BLACKSTONE COMMONS - BUILDING C

REV #	DESCRIPTION	DATE
	80% OHFA SET	12.19.25
	PERMIT SET	02.12.26
1	REVISION	05.13.26

1 PERMIT SET - REV 01
MAY 11, 2026

2 G3.04 ENLARGED FAIR HOUSING PLAN - UNIT B2 (504)

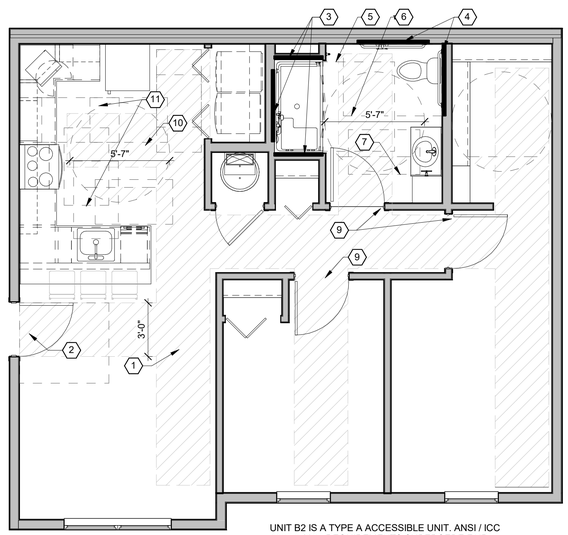
1 REVISED CLEAR FLOOR AREAS

1 G3.04 ENLARGED FAIR HOUSING PLAN - UNIT B1

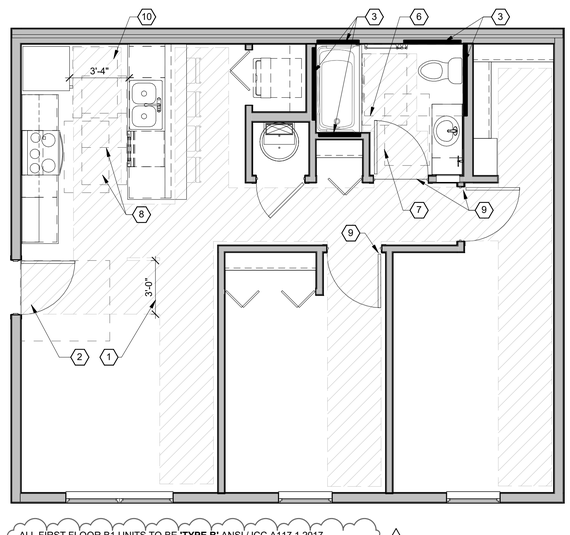
1 REVISED KITCHEN LAYOUT AND CLEAR FLOOR AREAS

1 AS1.03 ENLARGED ARCHITECTURAL SITE PLAN - EAST

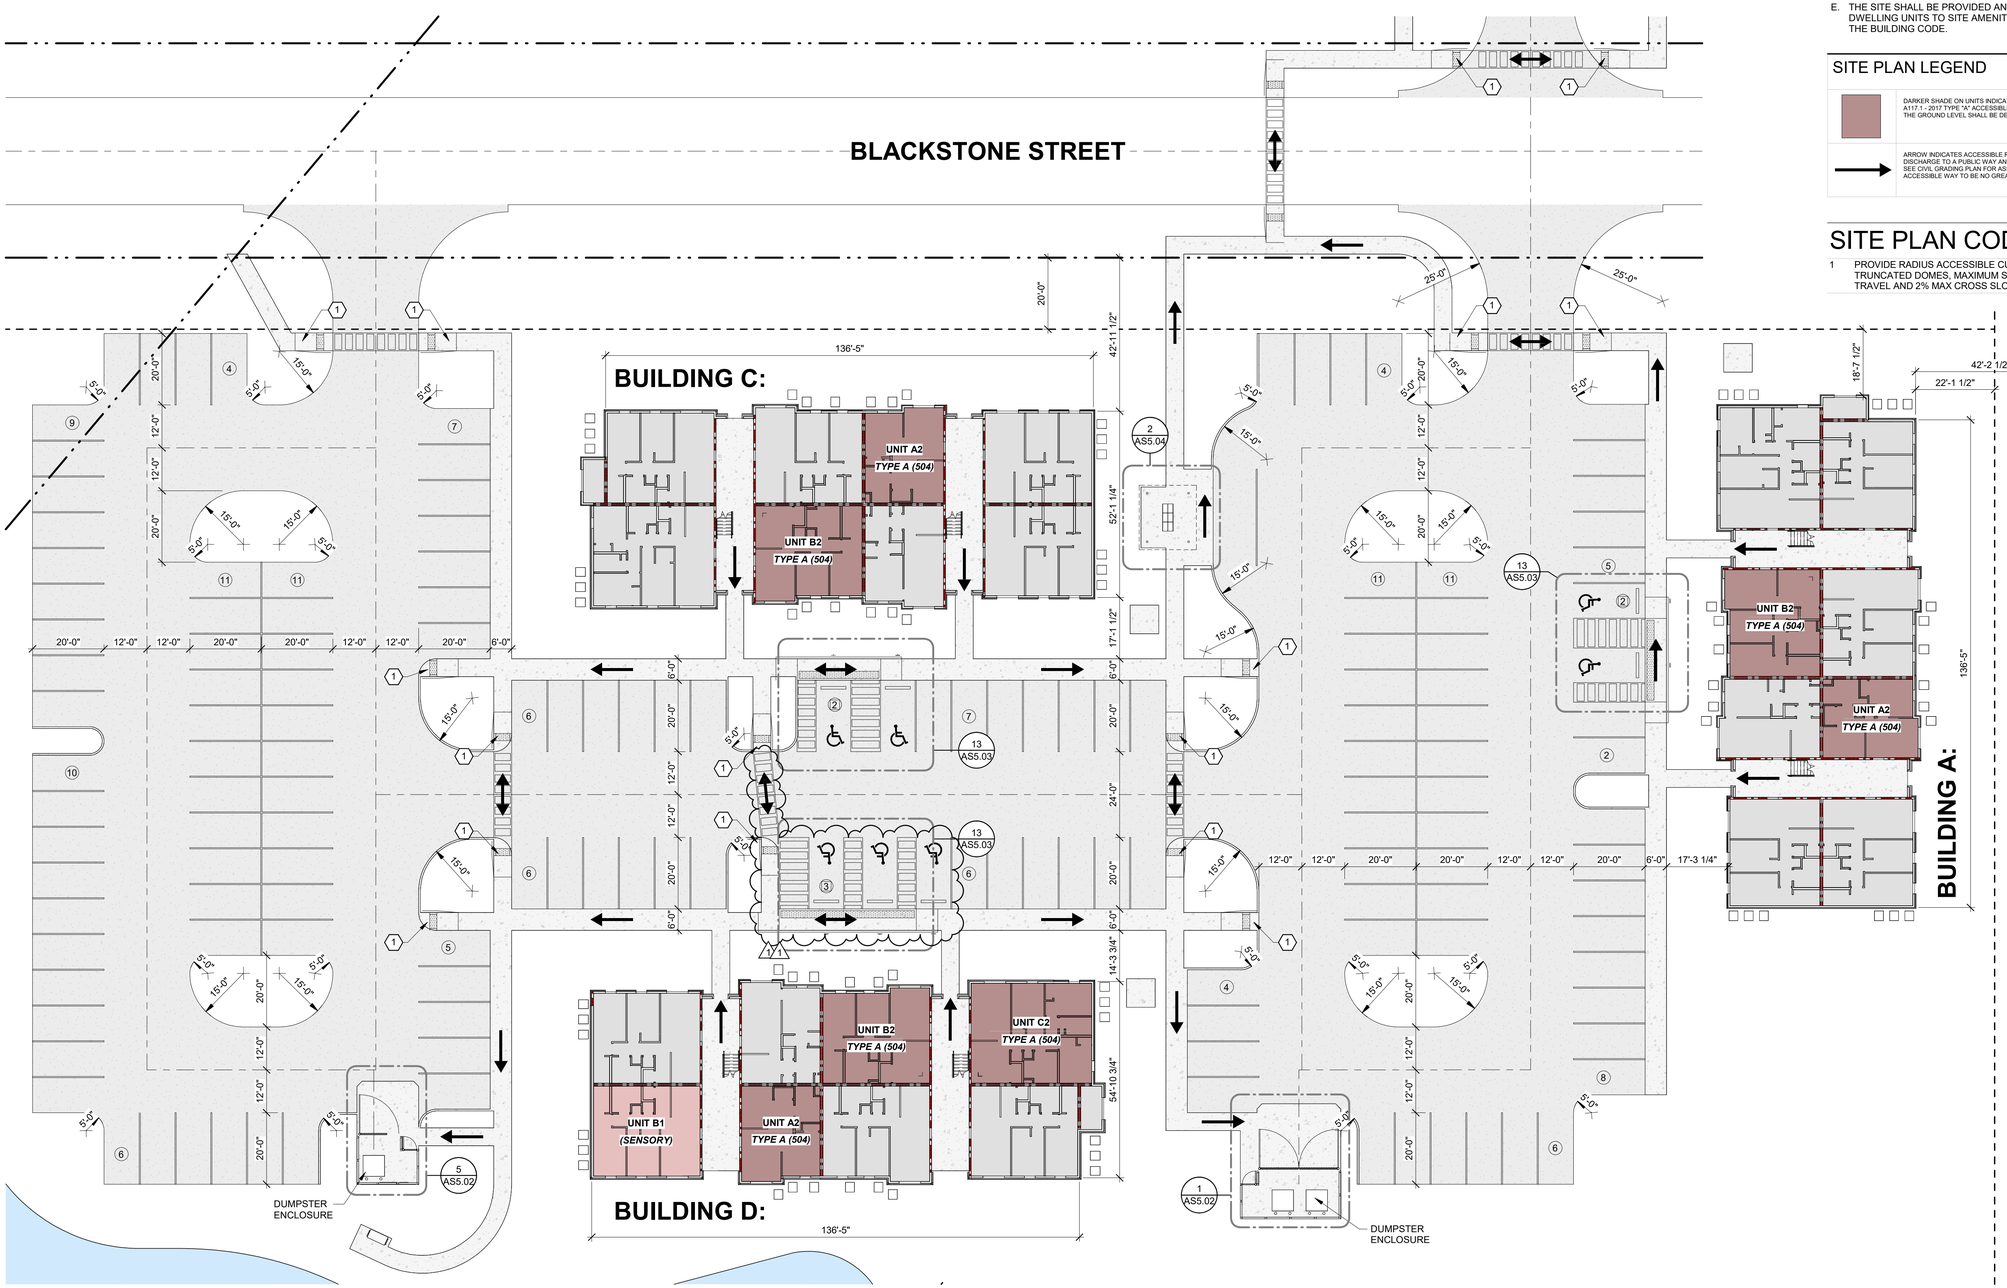
1 REVISED THE LOCATION OF PARKING, SIDEWALKS, CROSSWALKS, CURB RAMPS, DUMPSTER ENCLOSURE, ETC. TO MATCH 04.17.26 CIVIL SITE PLAN. ADDED ONE ADA STALL TO EAST SIDE OF SITE PER OHFA COMMENTS. REVISED POND TO MATCH 05.01.26 CIVIL SITE PLAN.

1 AS1.04 ENLARGED ARCHITECTURAL SITE PLAN - WEST
1" = 20'-0"

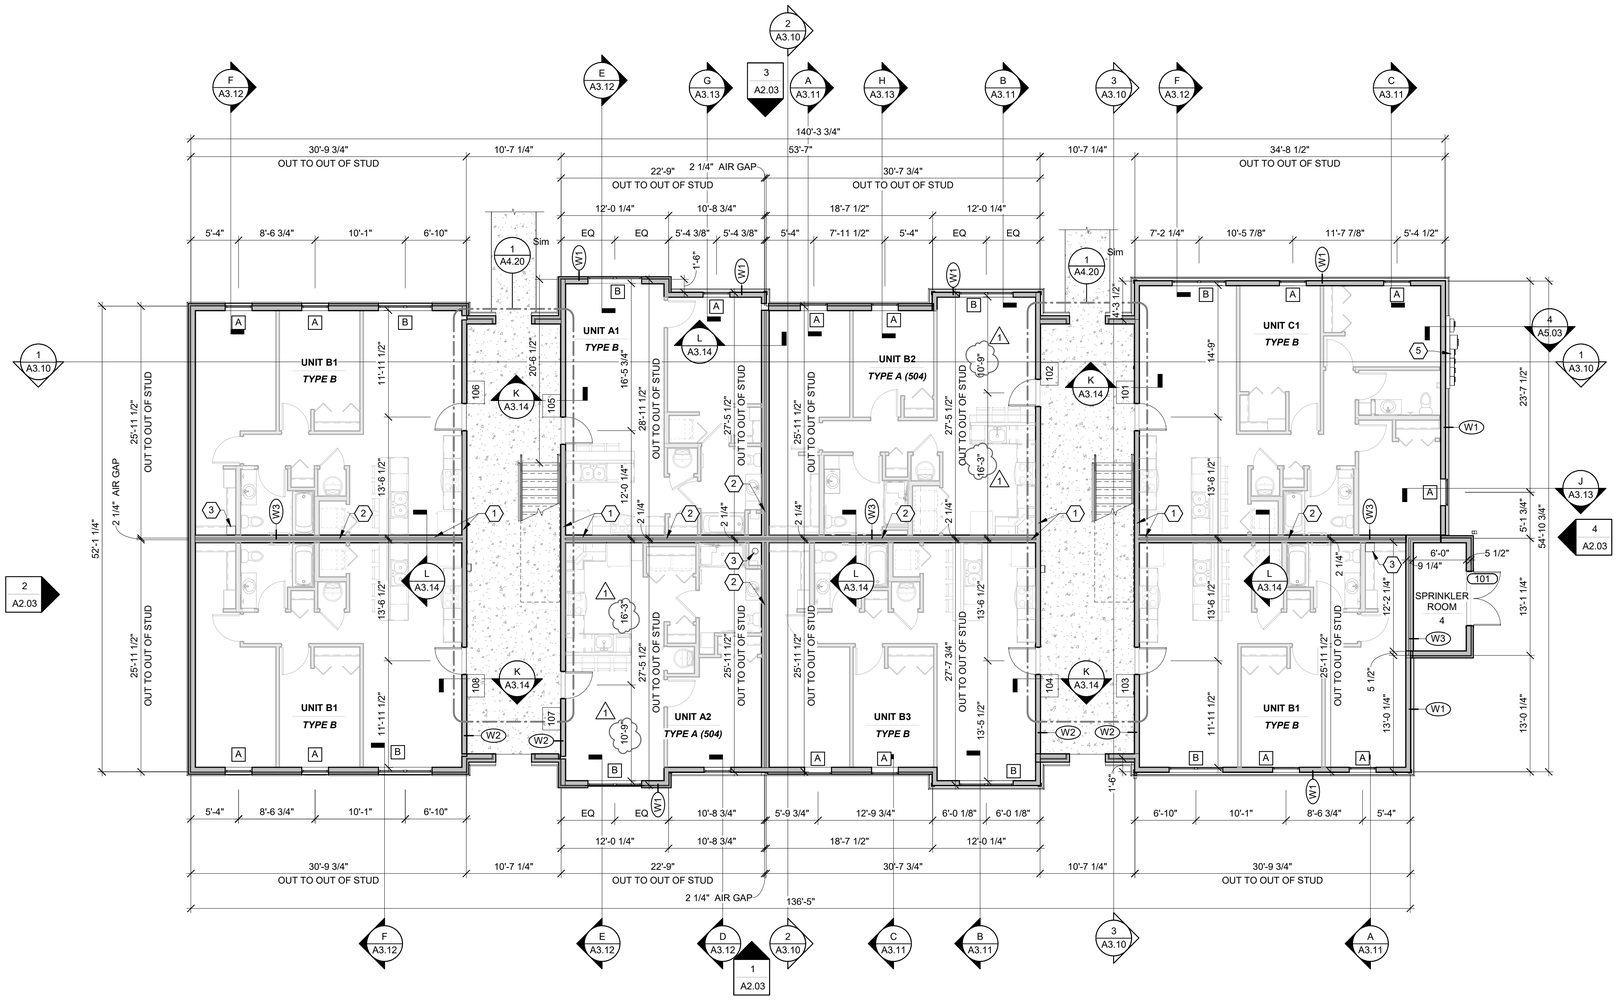
1 REVISED THE LOCATION OF PARKING, SIDEWALKS, CROSSWALKS, CURB RAMPS, DUMPSTER ENCLOSURE, ETC. TO MATCH 04.17.26 CIVIL SITE PLAN. ADDED ONE ADA STALL TO WEST SIDE OF SITE PER OHFA COMMENTS.

1 A1.01 — 1ST STORY PLAN

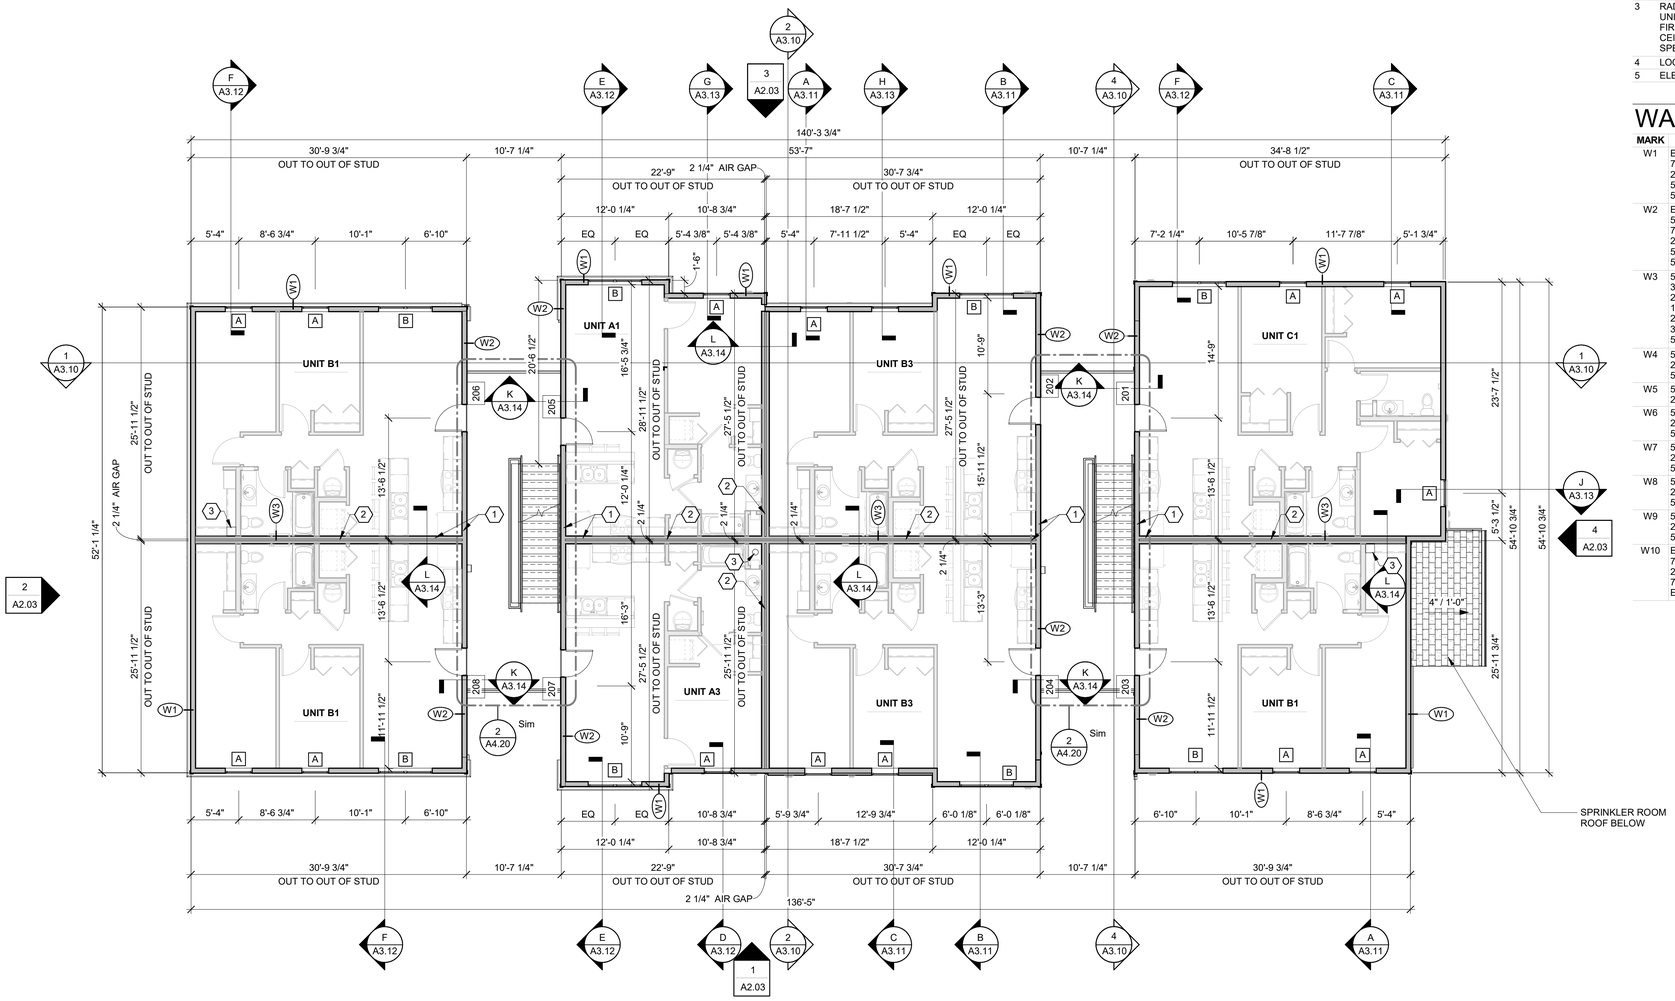
1 UNITS UPDATED WITH REVISED KITCHEN LAYOUTS

2ND STORY PLAN

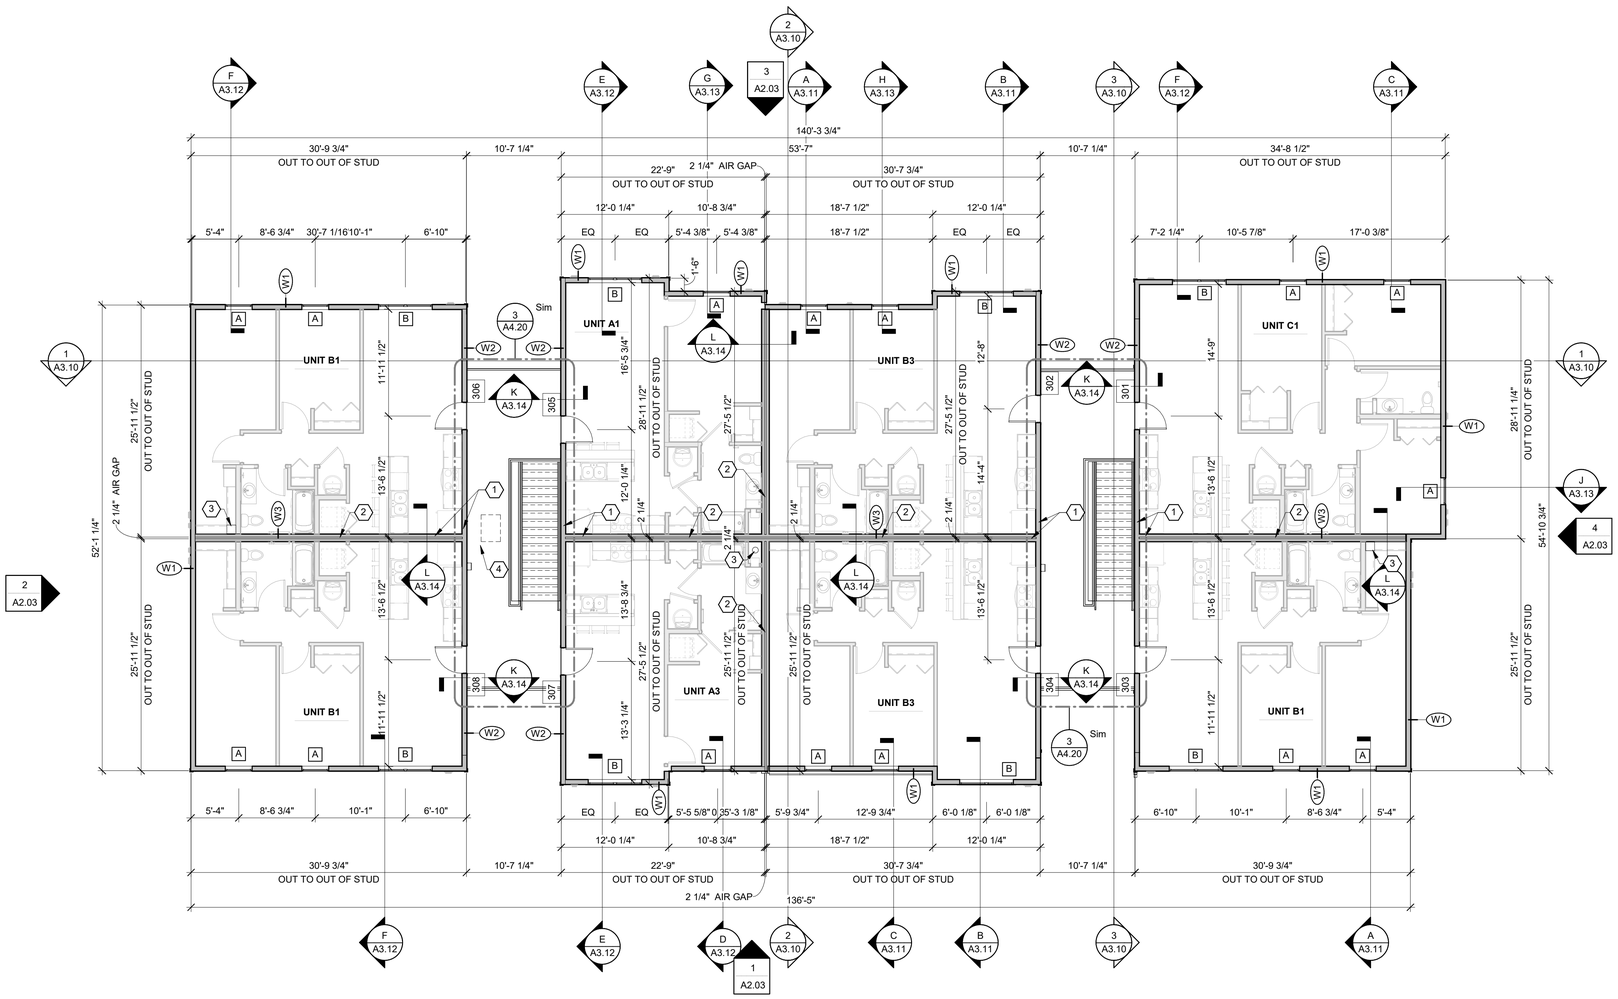
1 UNITS UPDATED WITH REVISED KITCHEN LAYOUTS

2 ENLARGED PLAN - UNIT B2 - TYPE A (504)

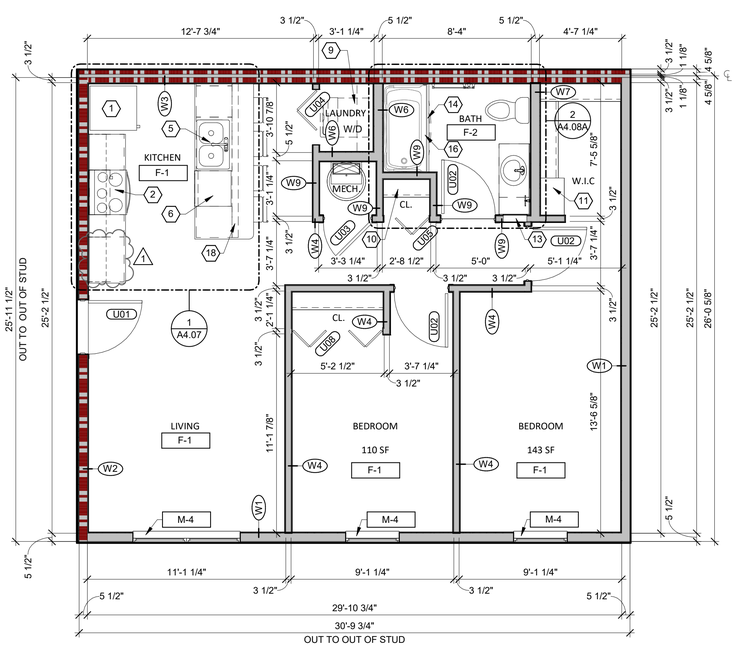
1 REVISED KITCHEN LAYOUT

2 A4.06 KITCHEN ENLARGED PLAN

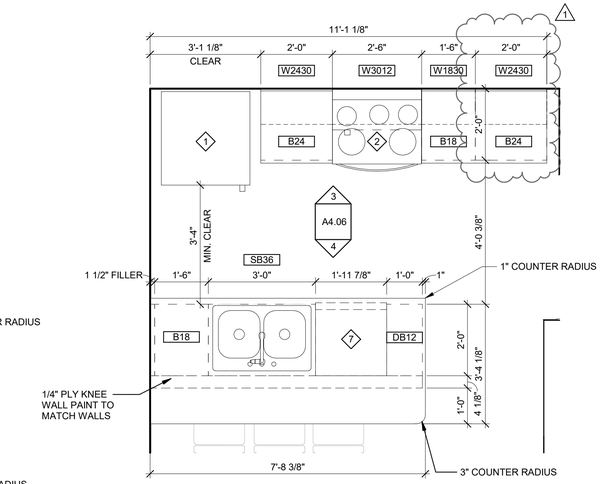
1 REVISED KITCHEN LAYOUT

B A4.21 STAIR SECTION

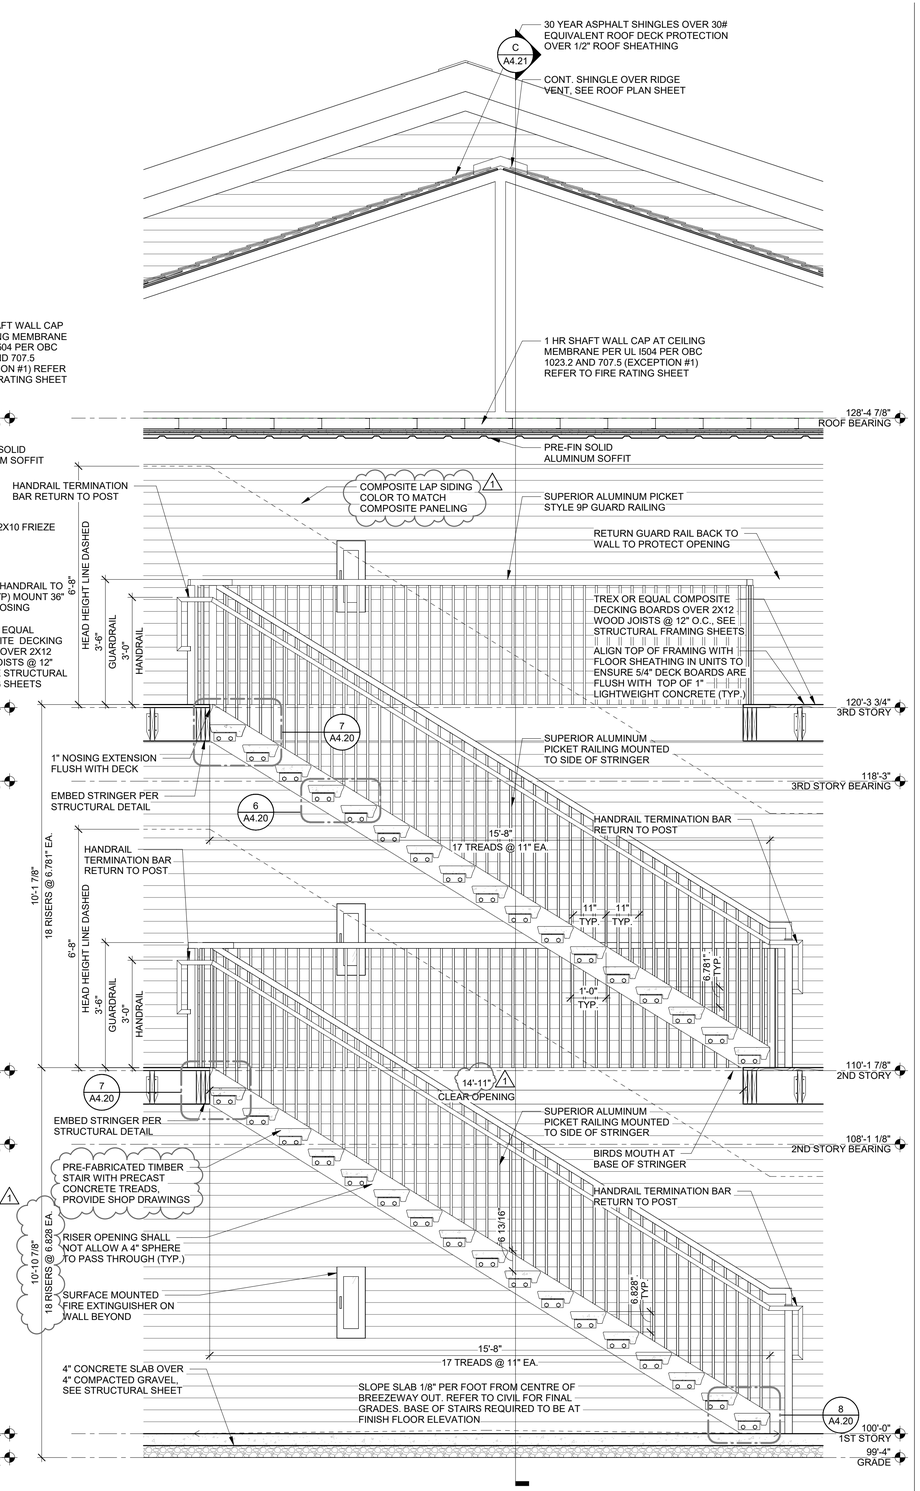
STAIR TREADS CHANGED TO PRECAST REINFORCED CONCRETE TREADS 1
